2.0 SAFETY LIMITS AND LIMITING SAFETY SYSTEM SETTINGS

DAVIS-BESSE, UNIT 1

Amendment No. 17, 18, 22
8, 17, 80

Figure 2.1-1 Reactor Core Safety Limit

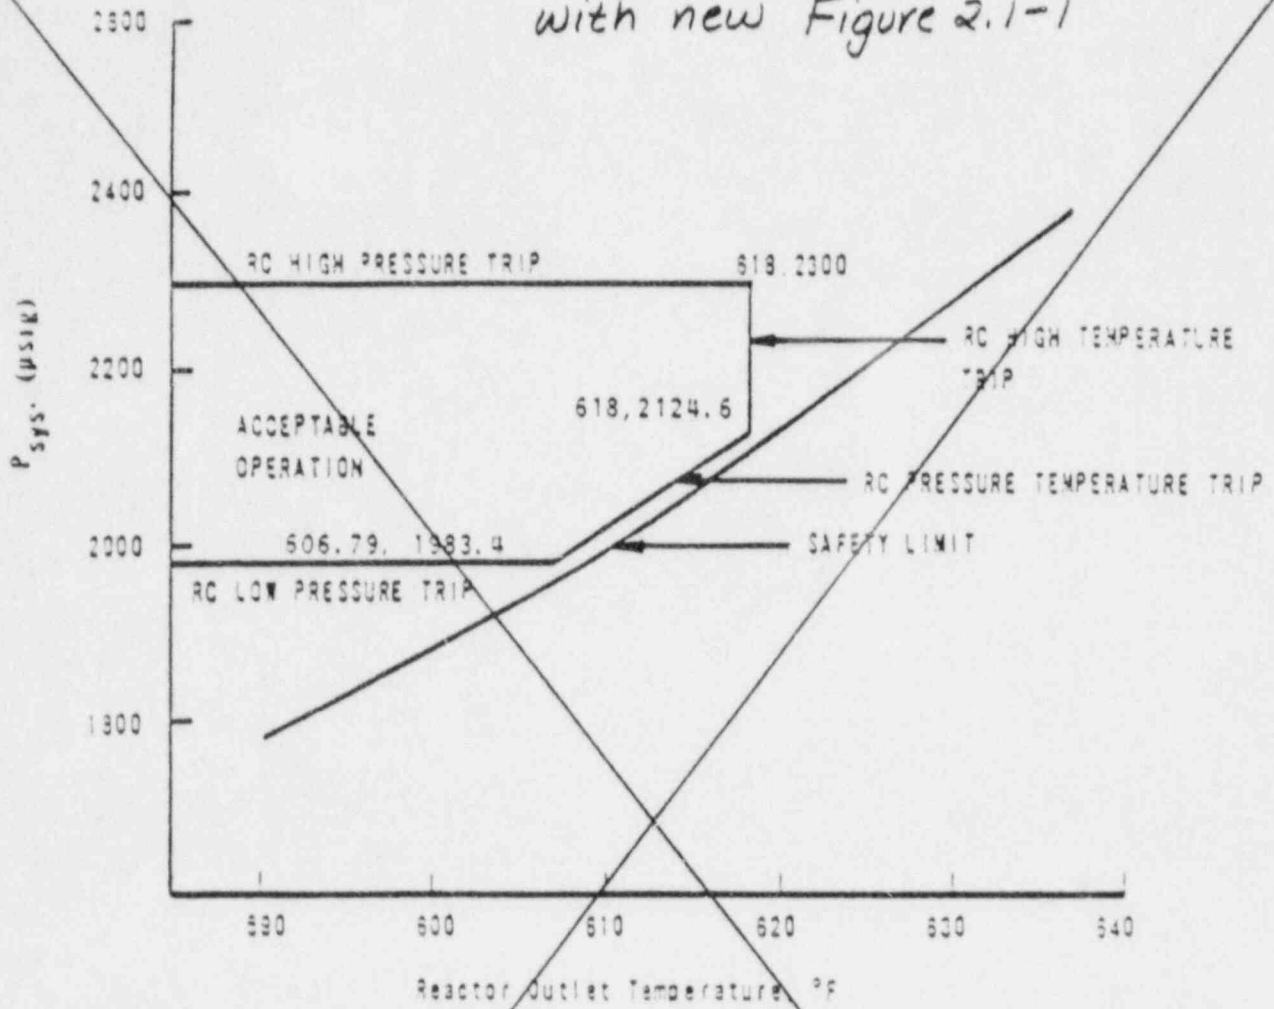
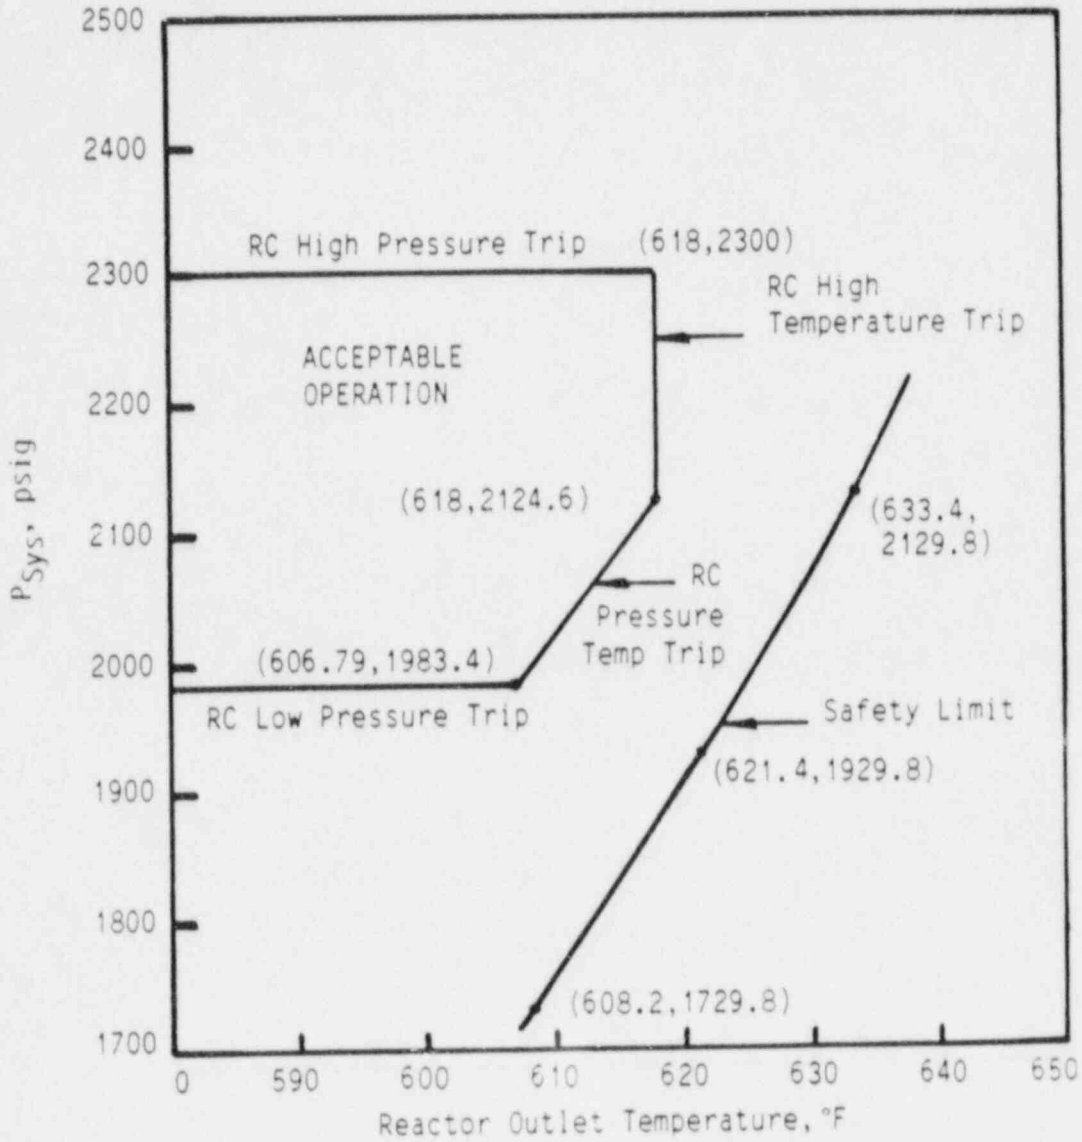
*Superseded
with new Figure 2.1-1*

The curve presented in Figure 2.1-1 represents the conditions at which a minimum DNBR of 1.30 is predicted for the maximum possible thermal power 1125 when the reactor coolant flow is ~~389,160~~ ^{350,000} GPM, which is ^{approximately} 108% of design flow rate for four operating reactor coolant pumps. This curve is based on the following hot channel factors with potential fuel densification and fuel rod bowing effects:

Figure 2.1-2 Reactor Core Safety Limit

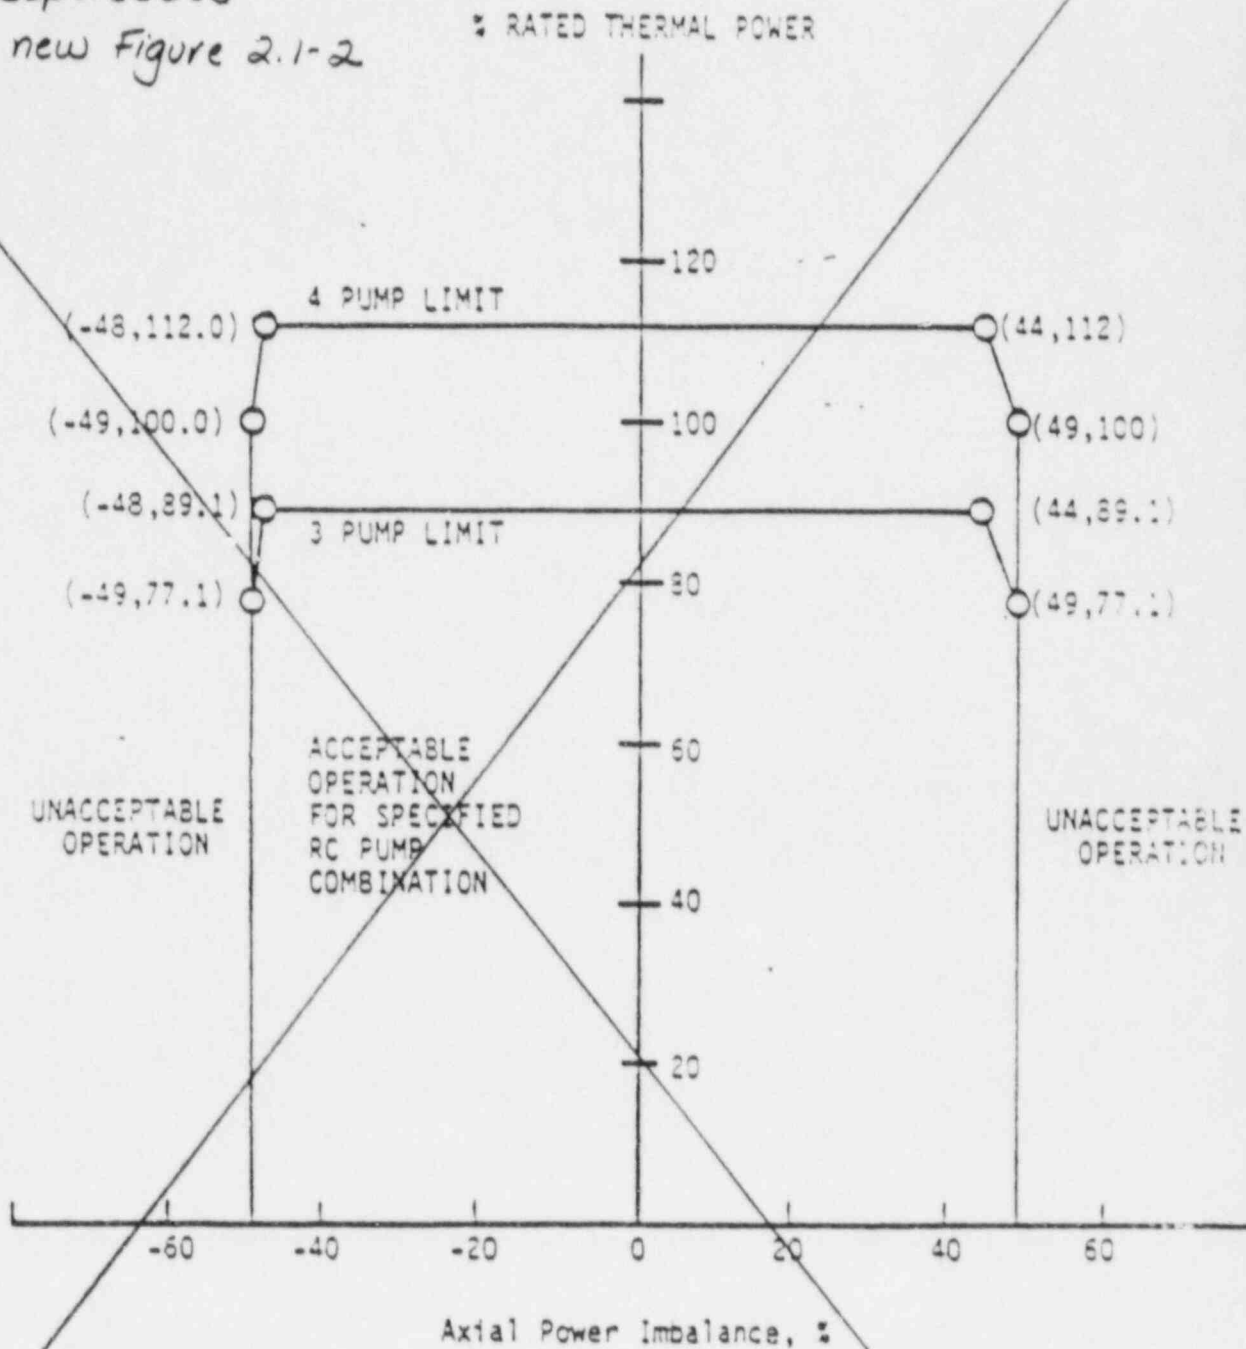
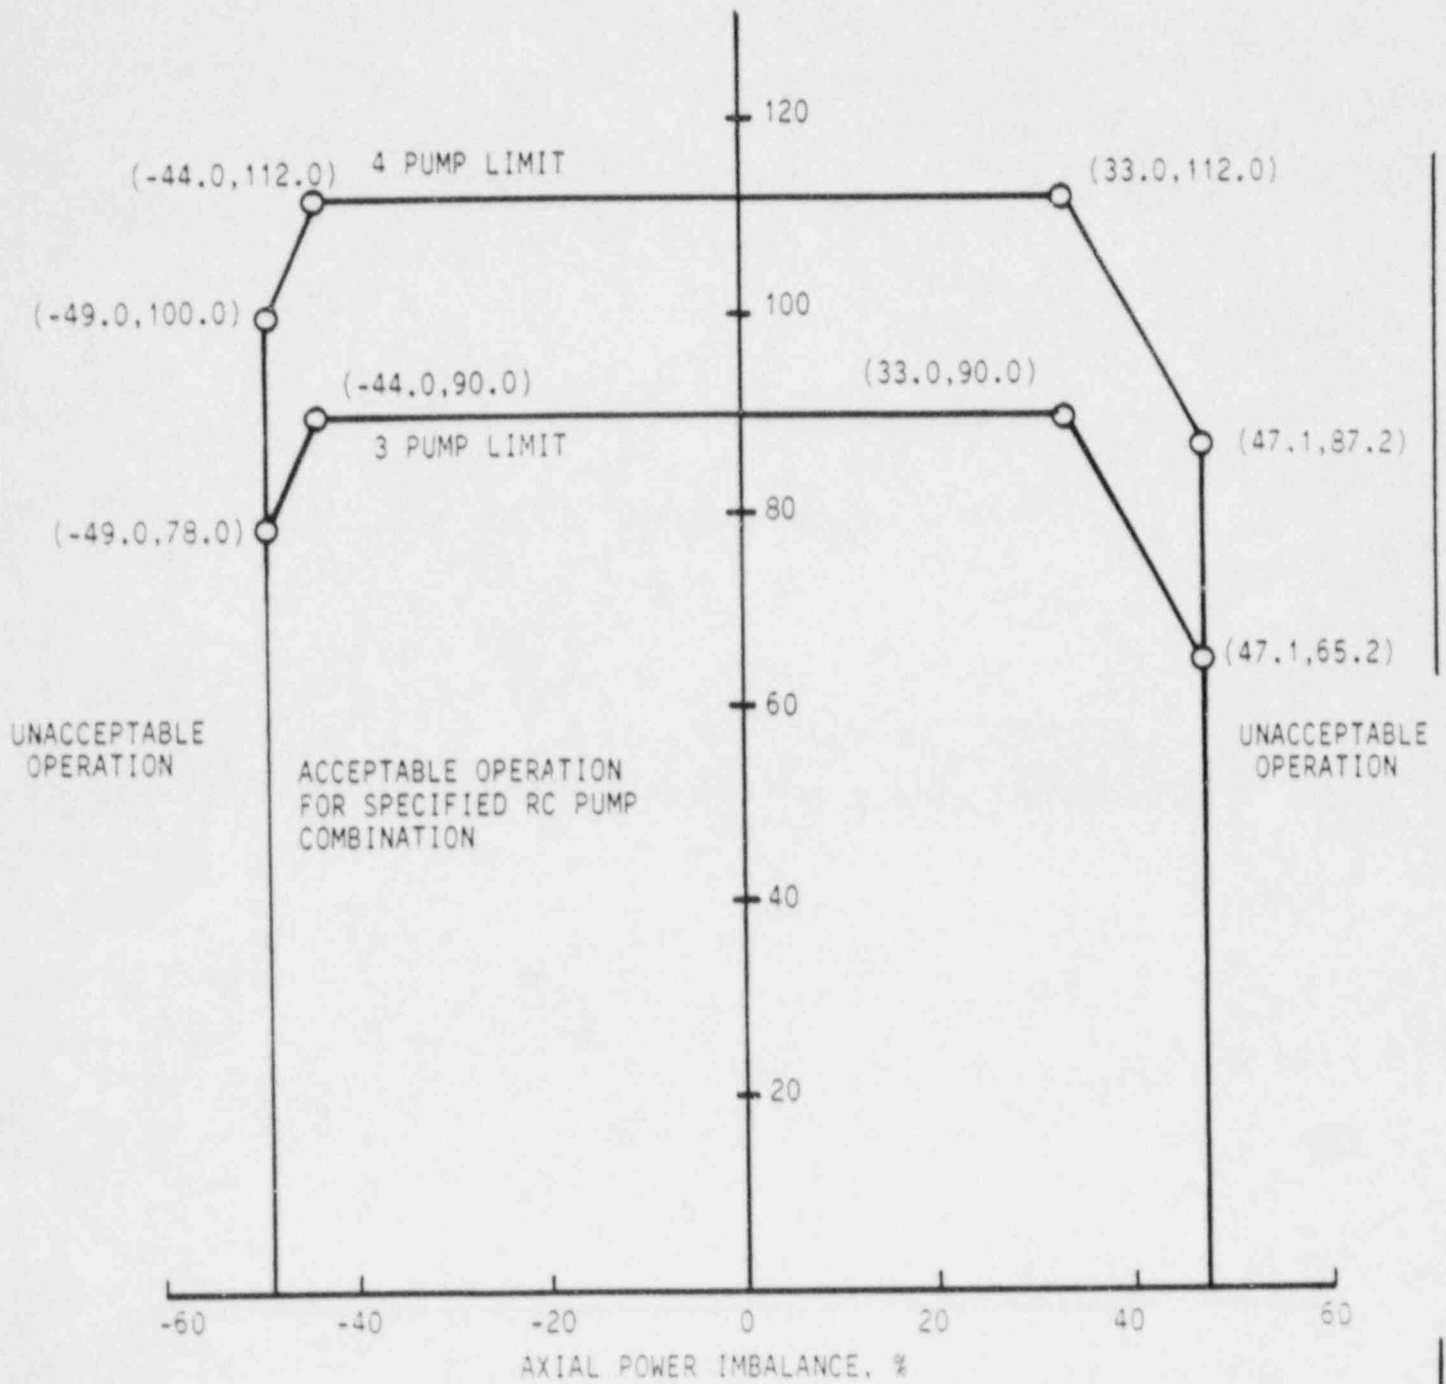
*Superseded
with new Figure 2.1-2*

The specified flow rates for ^{the two} curves 1 and 2 of Figure 2.1-2 correspond to the ~~expected~~ ^{analyzed} minimum flow rates with four pumps and three pumps, respectively.

<u>Pumps Operating</u>	<u>Reactor Coolant Flow, gpm</u>	<u>Required Flow to Ensure Compliance, gpm</u>
4	380,000	389,500
3	283,860	290,957

Figure 2.2-1 Trip Setpoint for Flux -- $\Delta\text{Flux}/\text{Flow}$

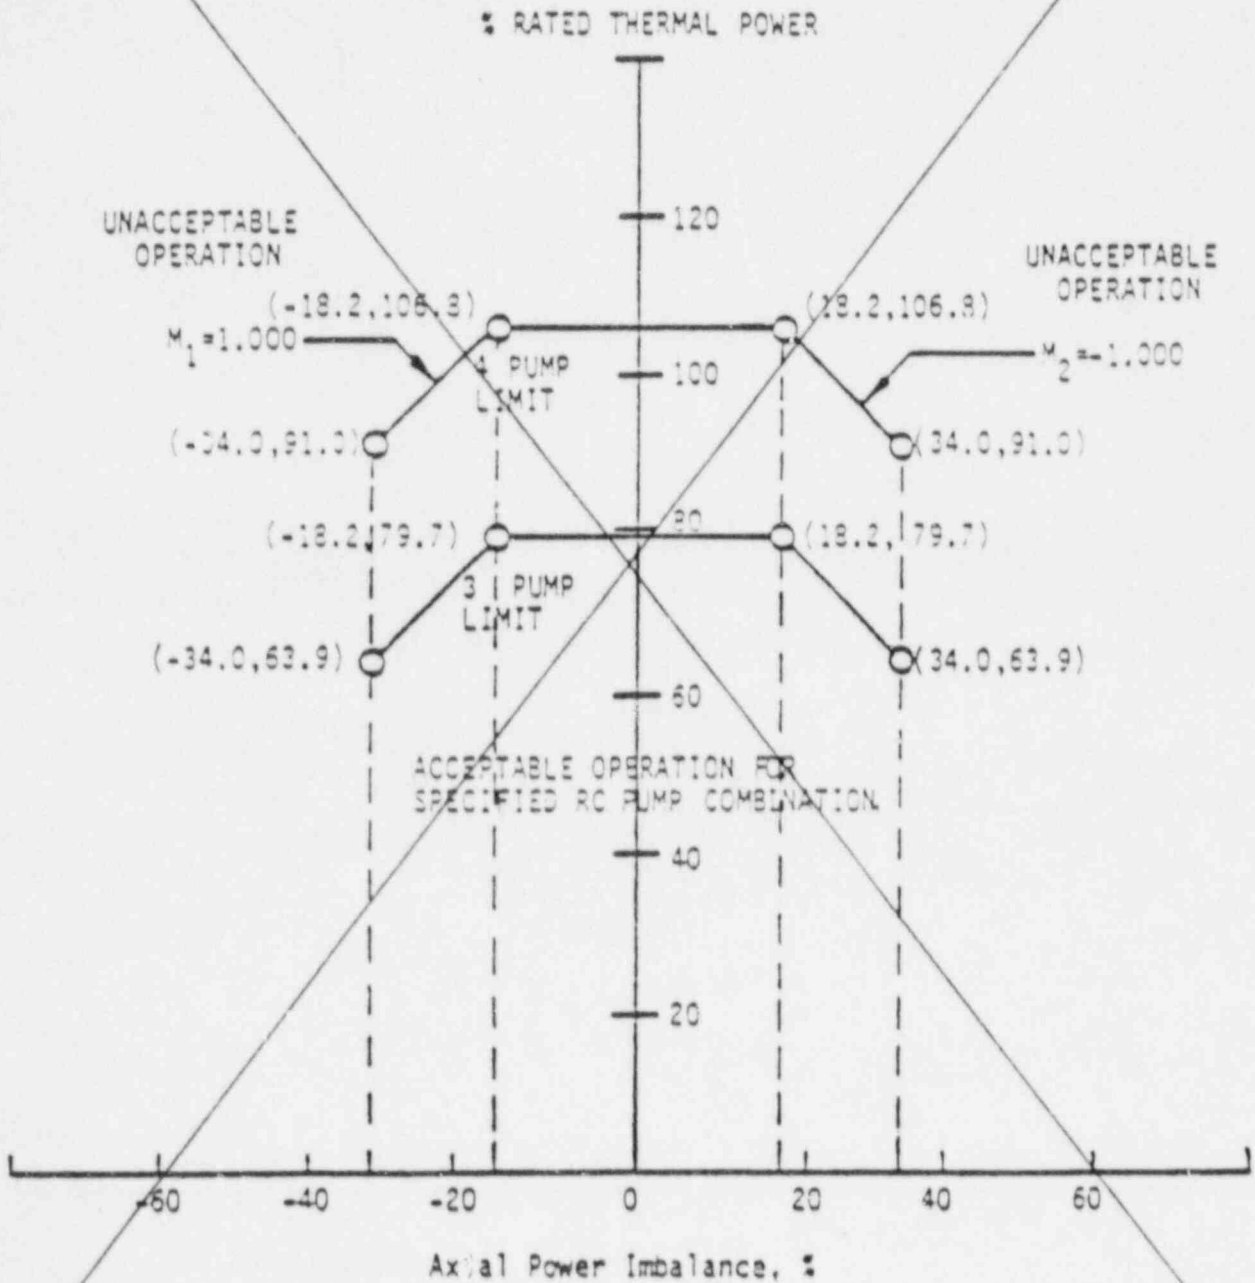
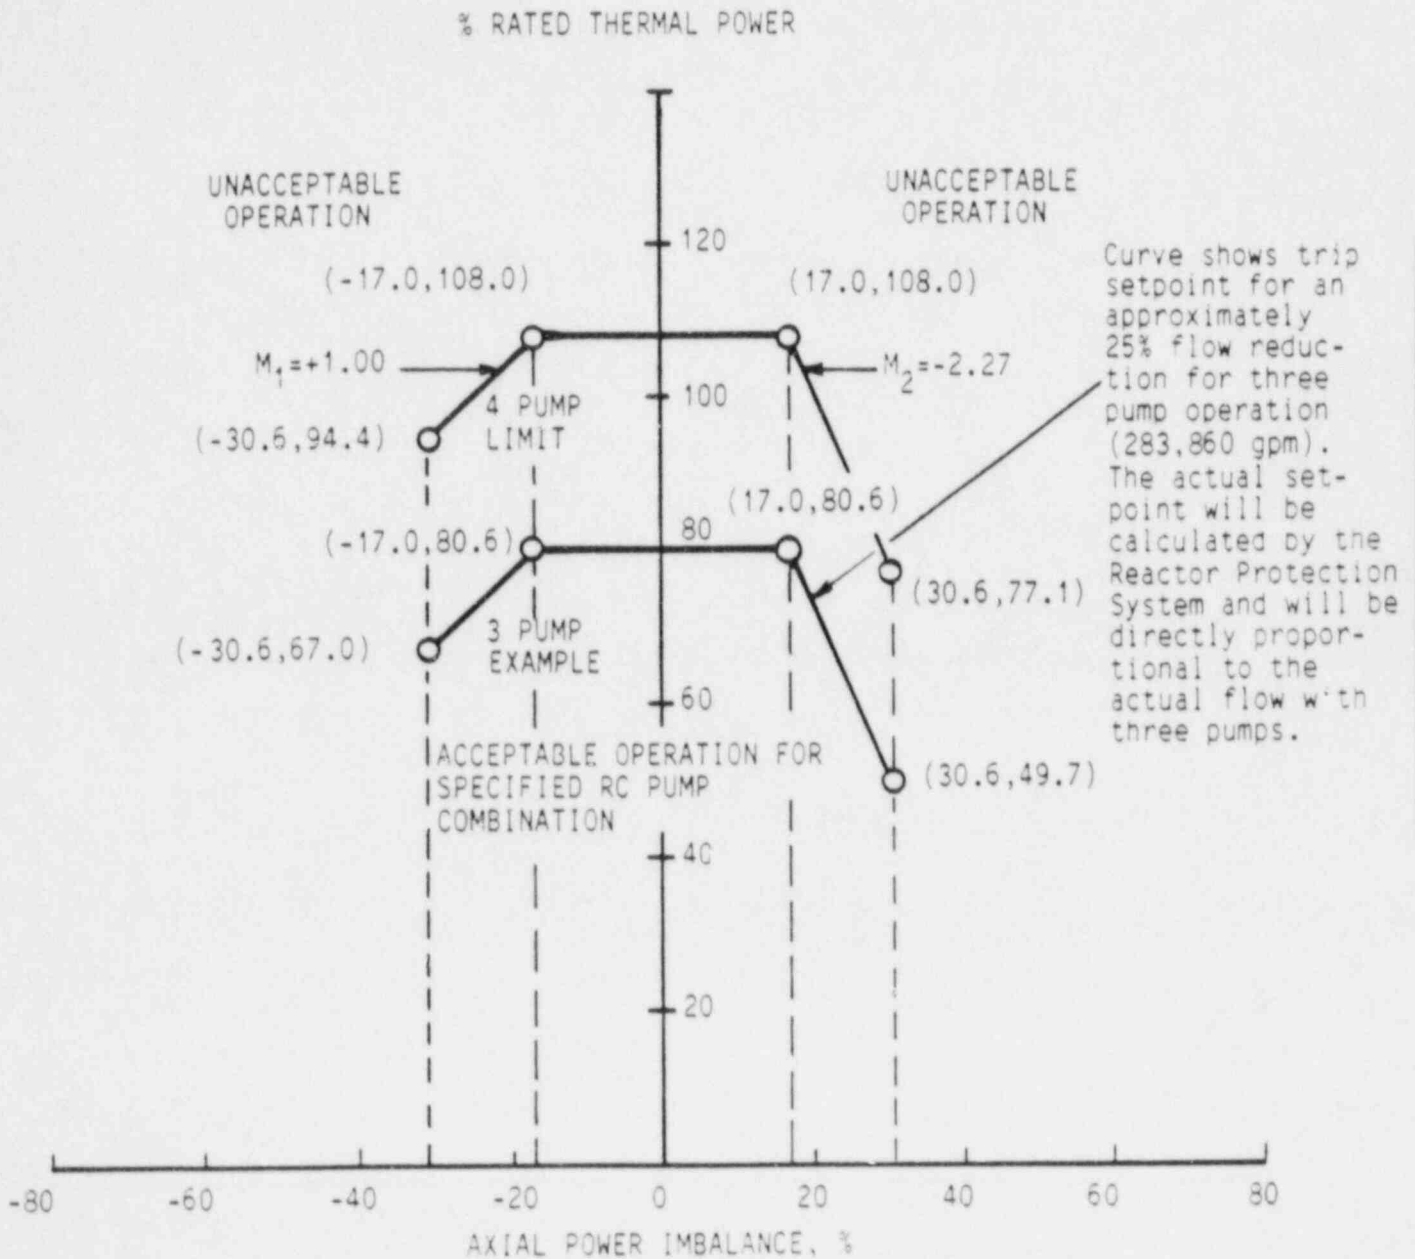
Superseded with new Figure 2.2-1

Note that the value of 80.6% in Figure 2.2-1 was truncated from the calculated value of 80.68%.

Bases Figure 2.1 Pressure/Temperature Limits at Maximum Allowable Power for Minimum DNBR

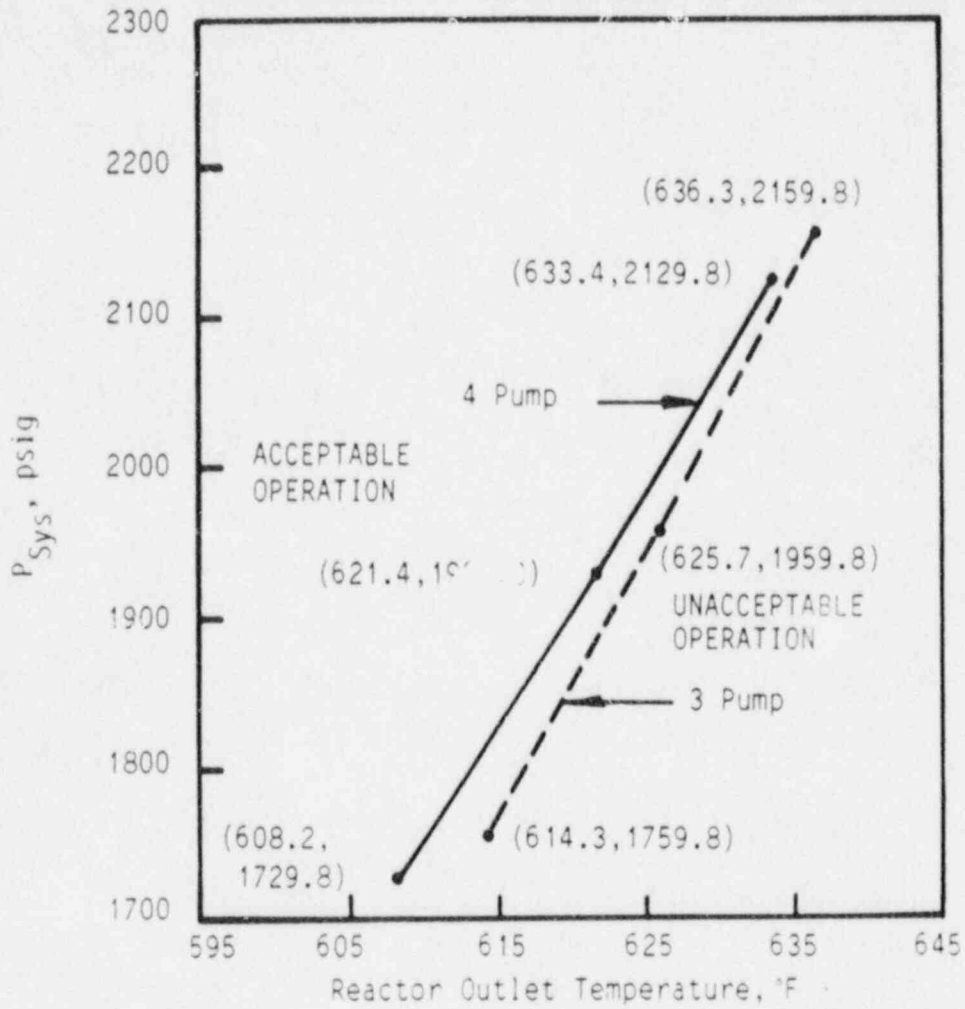
*Superseded with new Bases
Figure 2.1*

Pumps	Flow, gpm	Power	Required Measured Flow to ensure Compliance, gpm
4	380,000	112%	389,500
3	283,860	90.5%	290,957
